## Addendum No. 001

Project: Blinn A & G  
Project No. 240566  
Date: 1/13/2025

Blinn Bldg A and G

BLINN BUILDINGS A & G

**M4.1**

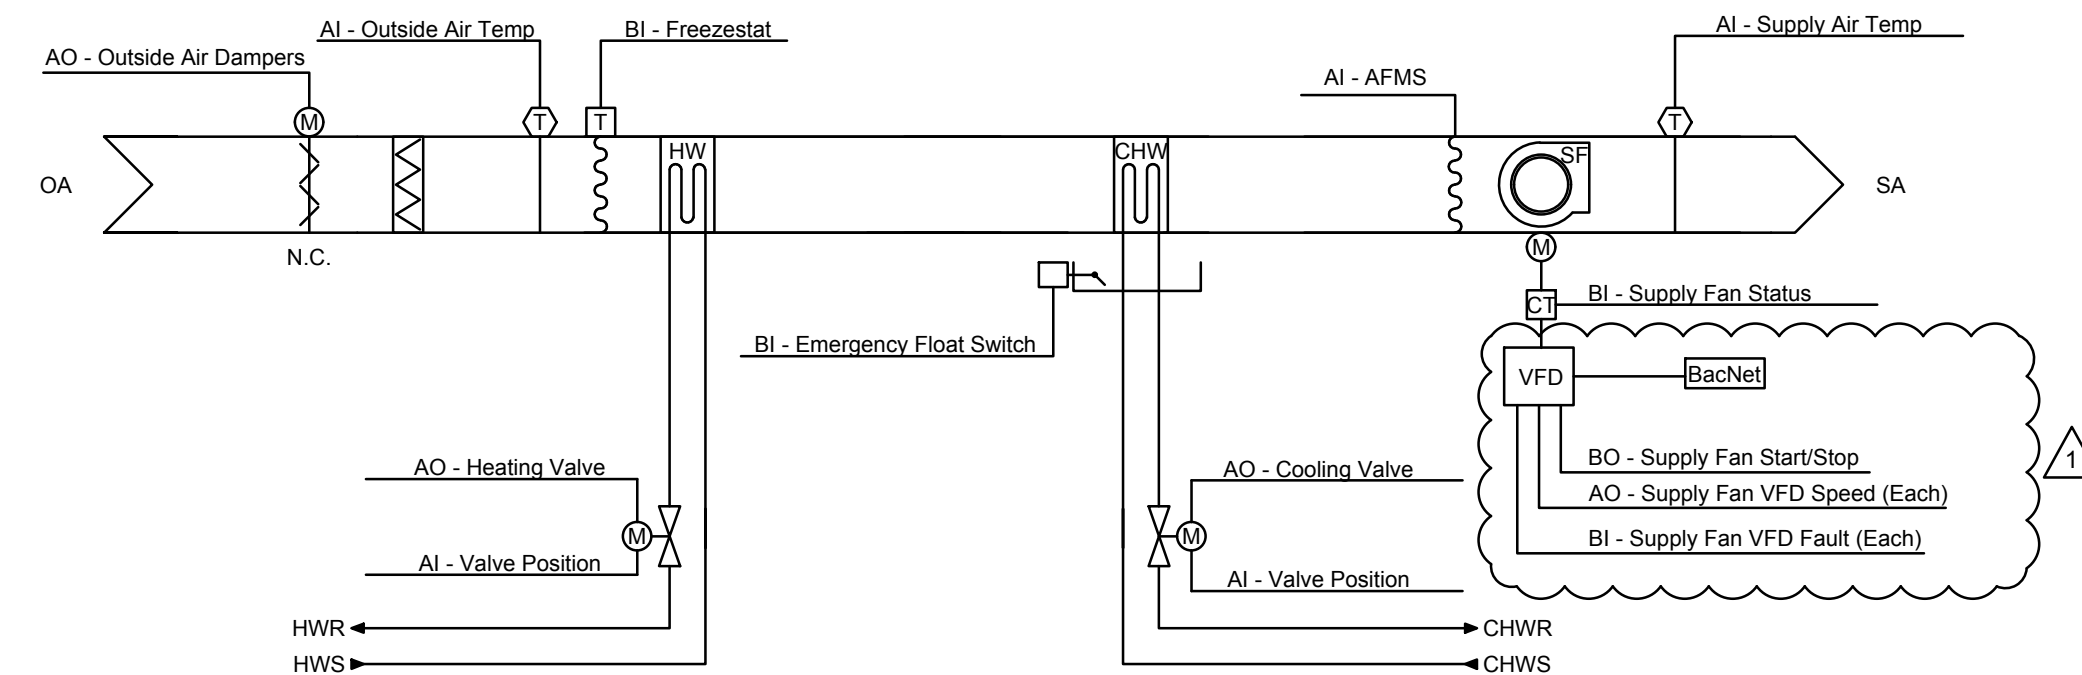
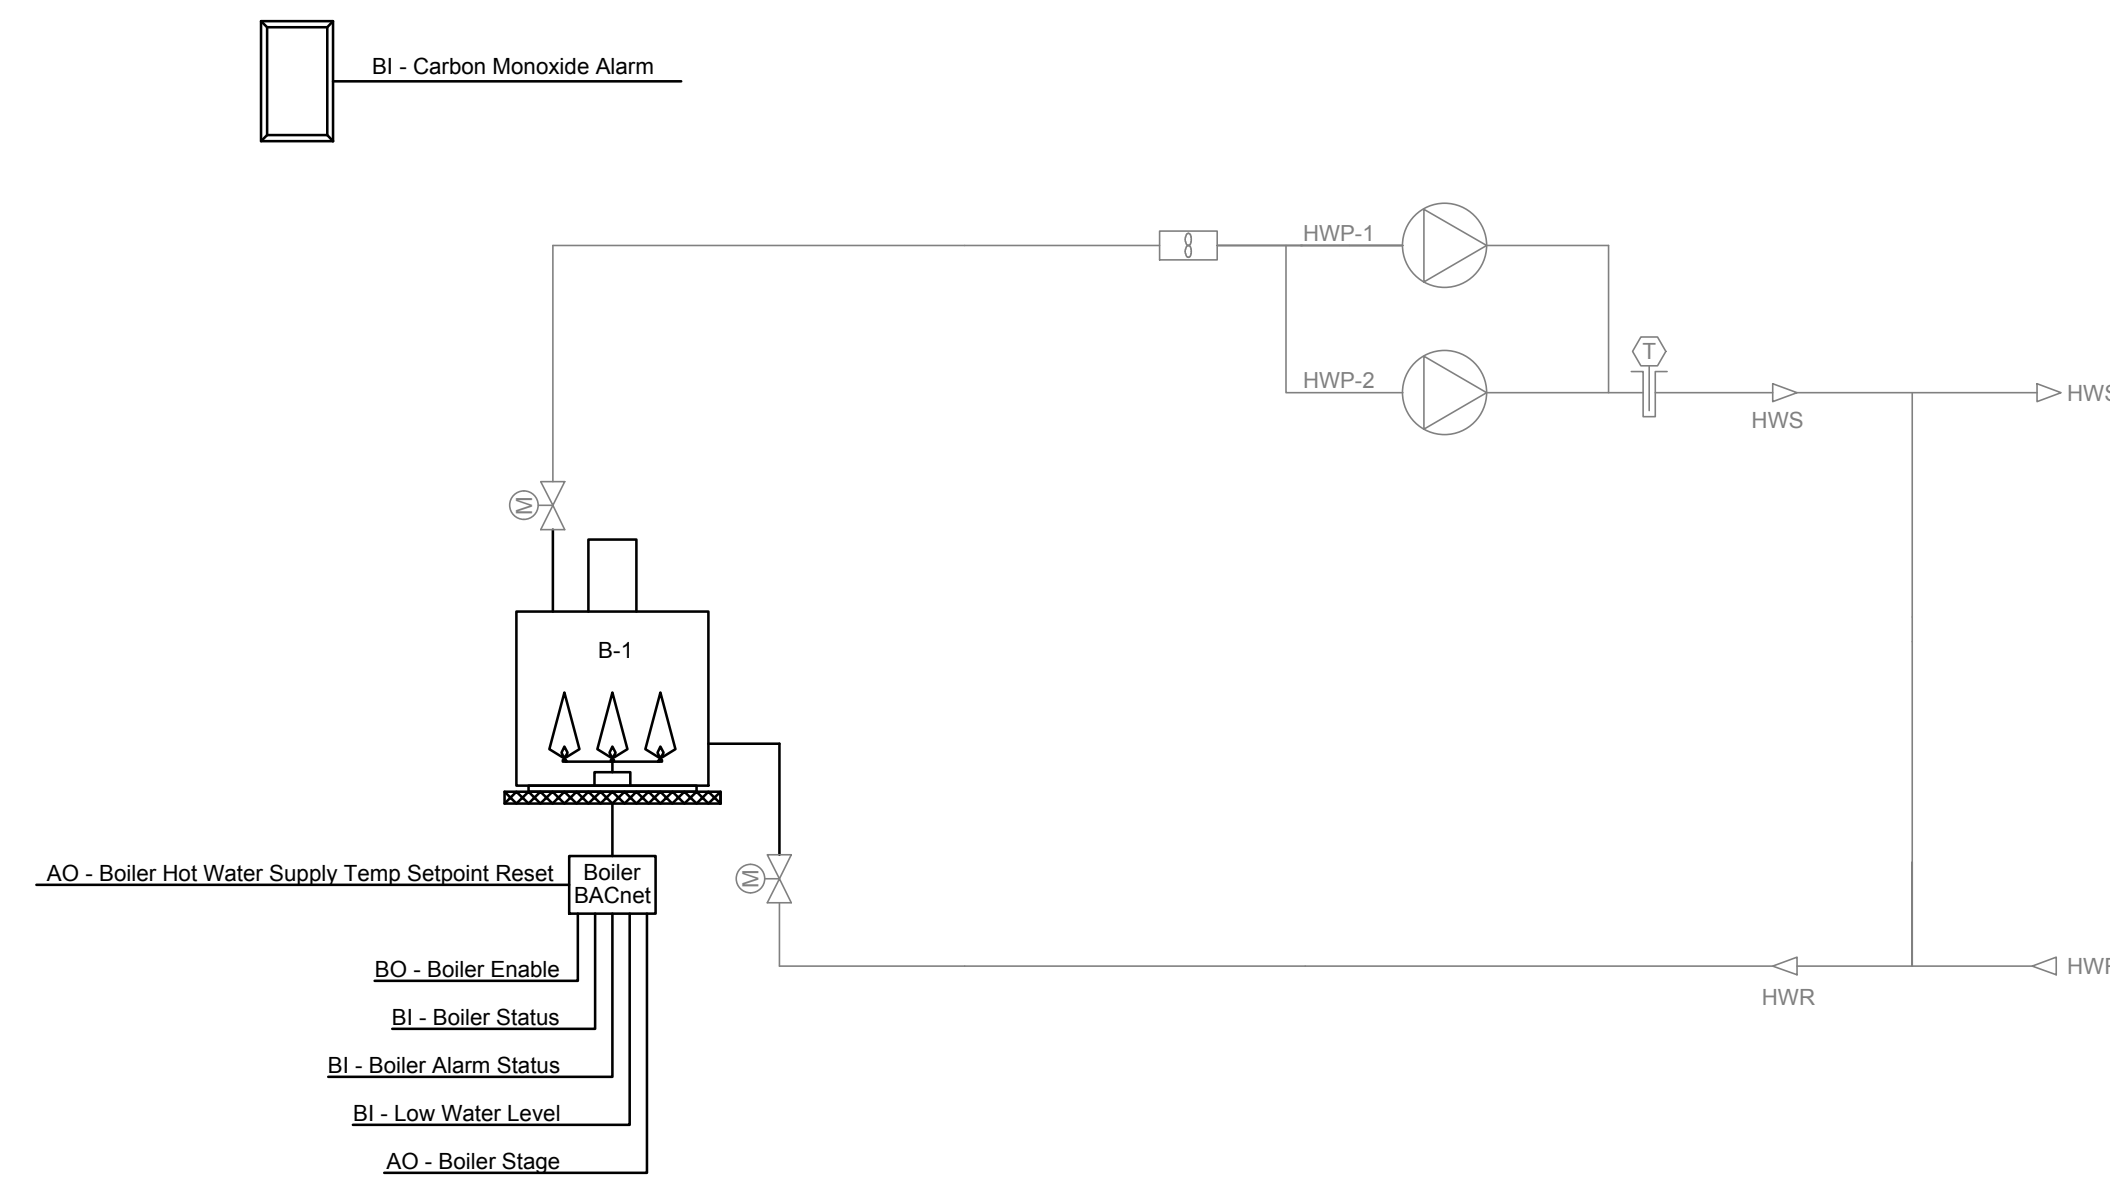
- a. AHU controls schematic has been modified.
  - b. AHU points list has been modified.
7. Sheet M4.2 – MEHCANICAL CONTROLS
  - a. Responsibility Matrix has been updated.

5. M4.1 I/O list and Responsibility matrix indicates a new Outside Air Flow Measuring Station to be provided by the Controls vendor. Upon site visit, with the current transition there is not applicable room to install the AFMS. Location and size will impact related pricing. Please advise

**Response: Refer to Addendum #1 changes on sheet M4.1 Responsibility Matrix. AFMS will be installed and provided with AHU by AHU manufacturer.**

**1 HOT WATER BOILER SCHEMATIC**  
M4.2 NOT TO SCALE

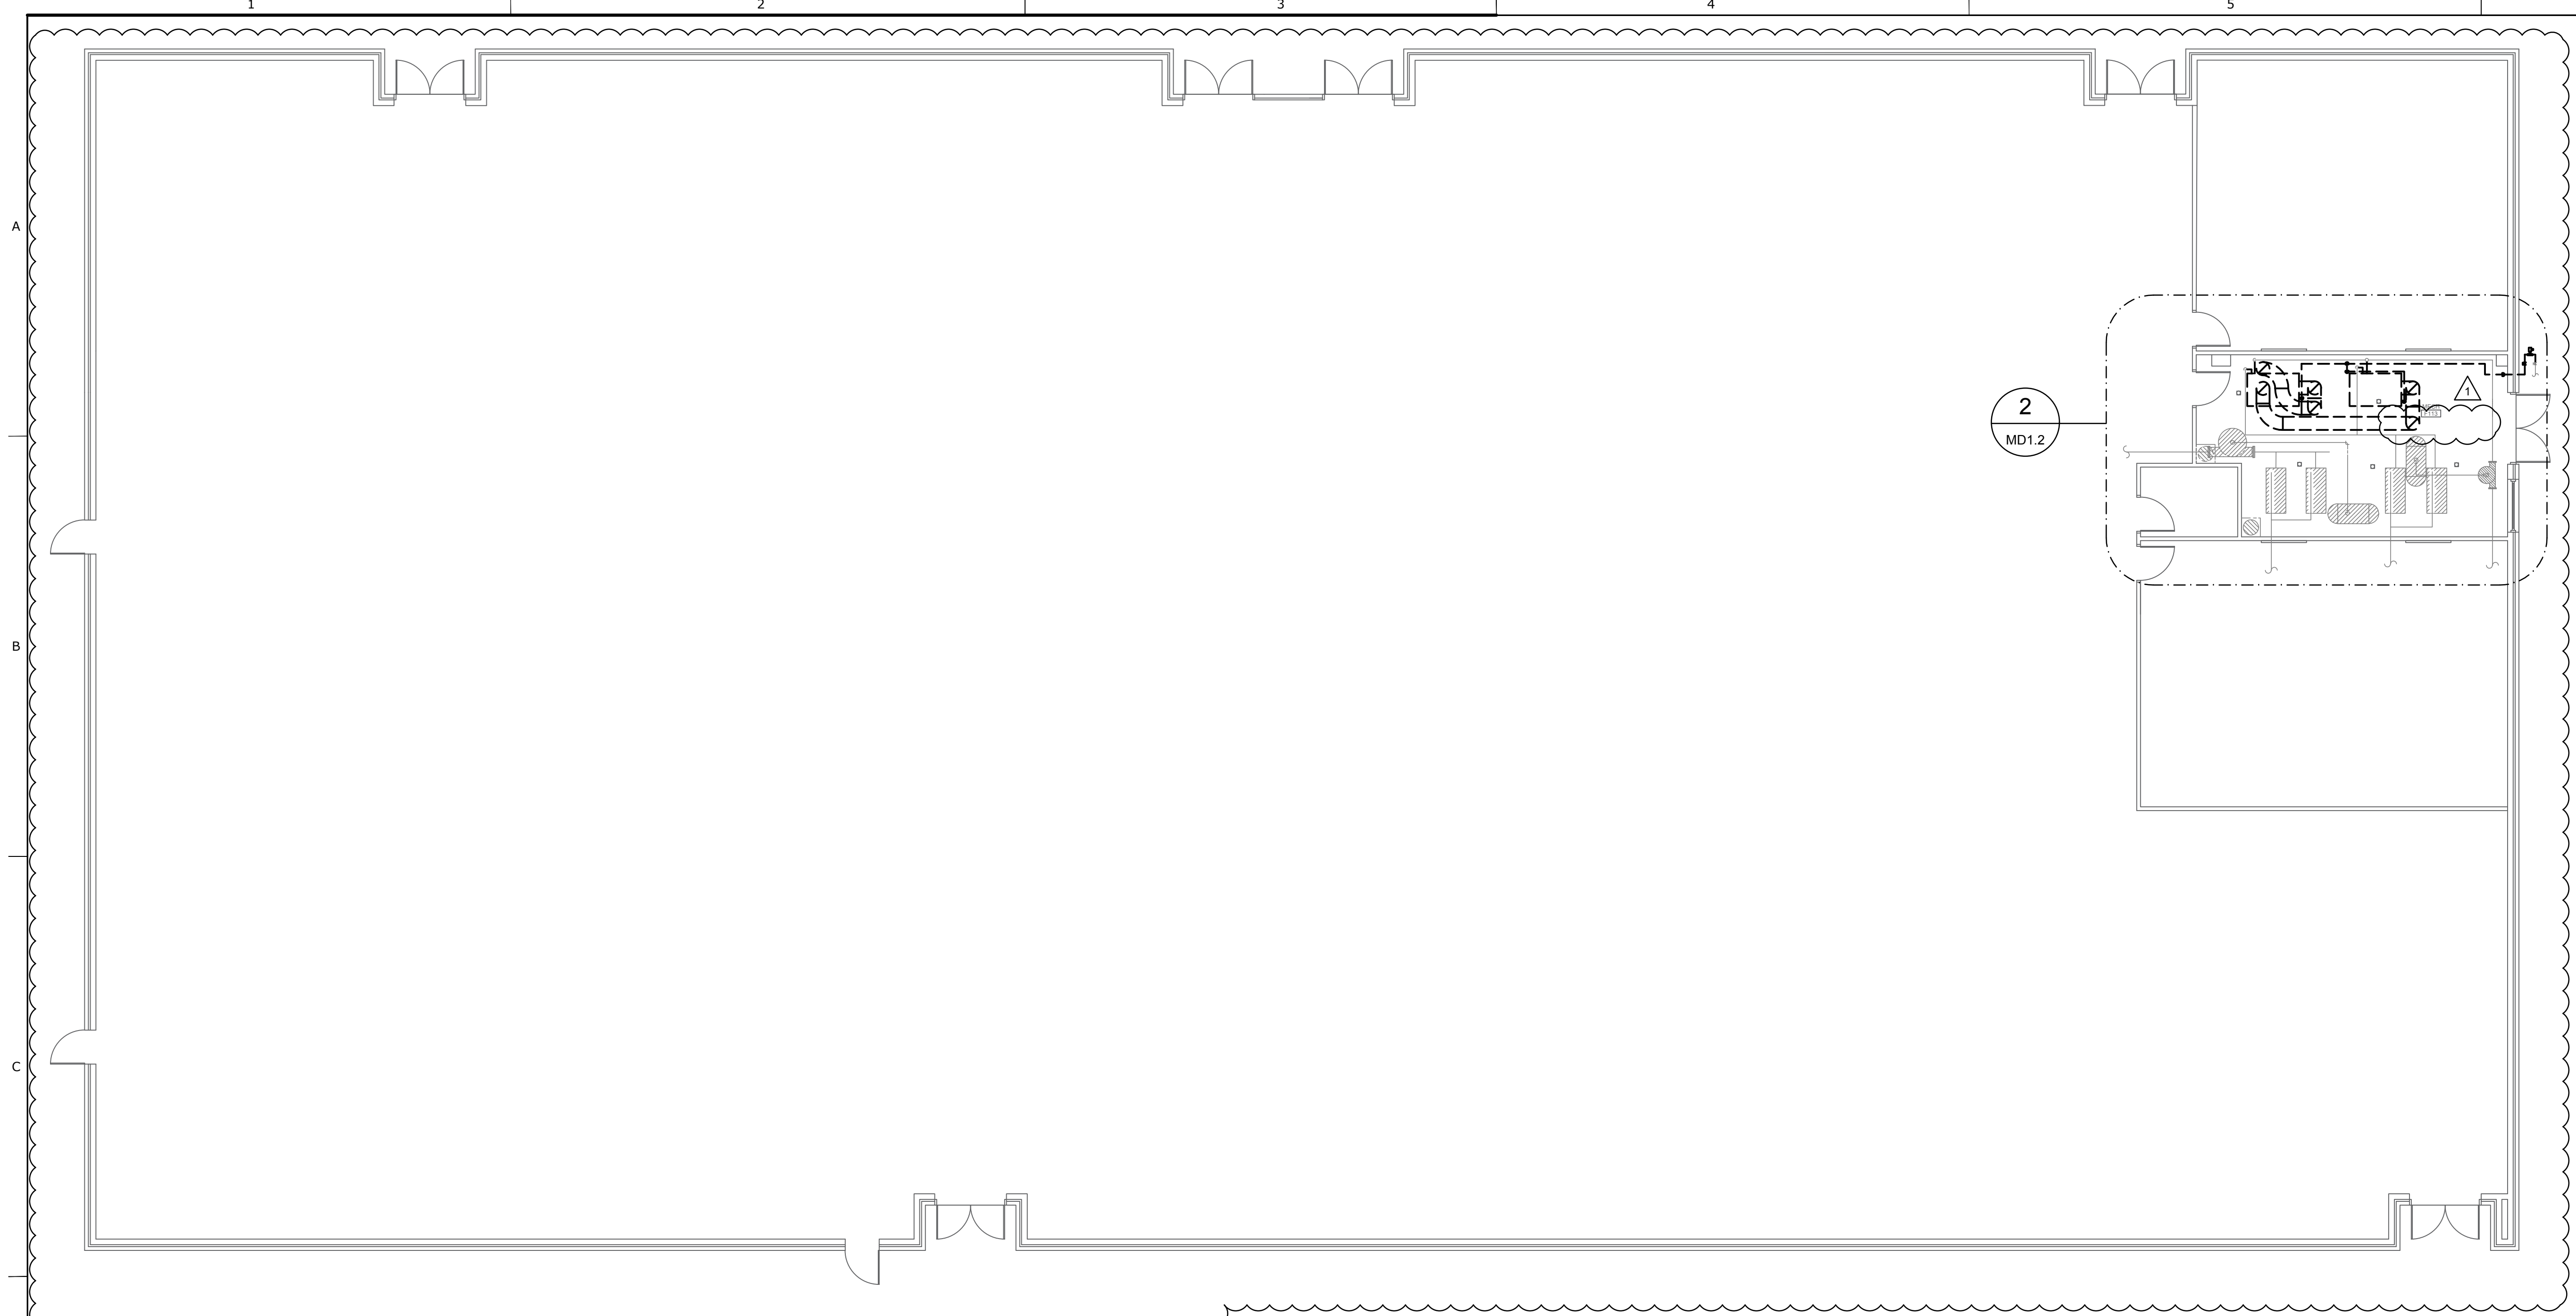
4. Sheet M3.1 Boiler Schedule
  - a. Note 6 indicates that indicates that the boiler is to be provided with an Oslin Nation CO100-N1 Carbon Monoxide Monitor. M4.2 Responsibility matrix indicates that the Carbon Monoxide sensor is provided by the Controls vendor. Please confirm who will provide.

**Response: Refer to Addendum #1 changes on sheet M4.2 Responsibility Matrix.**
